INT-G-16-01

Per Rule 54 I am making a complaint on behalf of myself (Owner of new property at 2277 Hendricks Circle) and all other new home owners in the counties of Freemont, Madison, Bonneville, Bingham and Caribou counties who have been required to install snow covers for gas meters.

Meter Protection

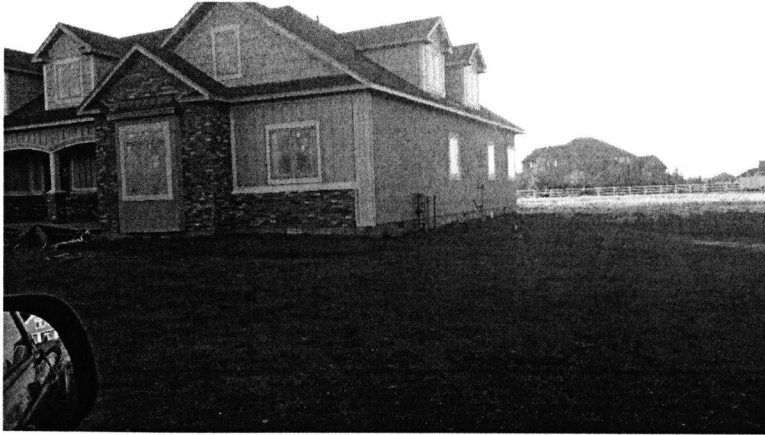
Gas Meter on East side of new home
built this summer, no gutters, you can
see splash near meter. Approved.
